Access Compliance Report Public Rights-of-Way (Curb Ramps)

Intersection ID: 10037795Main Street:SHARON_LAKES_RDCross Street:N/ALocation:SWADA ID: 6C702C59B976Ramp Type:MedianPerpInitial Pass/Fail:FailOverall Compliance:NoSeverity Score:25

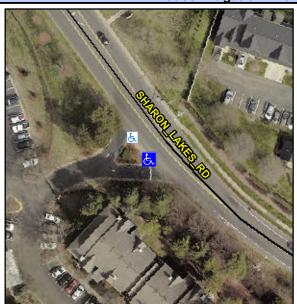
Not Found, R304.2.2

Field Measurements/Component Compliance					
Compliance Description		Data	Compliance Description		Data
N/A	Ramp Length (in)	25.5	No	Ramp Slope (%)	14.1
Yes	Ramp Width (in)	48.0	Yes	Ramp XSlope (%)	1.5
N/A	Flare Type LT	N/A	N/A	Flare Type RT	N/A
N/A	Flare Slope LT (%)	N/A	N/A	Flare Slope RT (%)	N/A
N/A	Flare Traversable LT?	N/A	N/A	Flare Traversable RT?	N/A
N/A	Landing Length (in)	N/A	N/A	DWS Provided?	N/A
N/A	Landing Width (in)	N/A	N/A	DWS Contrast?	N/A
N/A	Landing Slope (%)	N/A	N/A	DWS Length (in)	N/A
N/A	Landing X Slope (%)	N/A	N/A	DWS Full Width?	N/A
N/A	Landing Curb? (Y/N)	N/A	N/A	DWS Offset (in)	N/A
N/A	Shared Landing?	N/A			
N/A	Gutter Ponding?	N/A	N/A	Gutter Slope (%)	N/A
N/A	Gutter Lip Ht (in)	N/A	N/A	Gutter X Slope (%)	N/A
N/A	Painted X Walk1?	No	N/A	Painted X Walk2?	N/A
	X Walk 1 Direction	To S		X Walk 2 Direction	N/A
N/A	X Walk 1 Width (in)	N/A	N/A	X Walk 2 Width (in)	N/A
	X Walk 1 Slope (%)	0.5		X Walk 2 Slope (%)	N/A

Remove & Replace Entire Ramp.
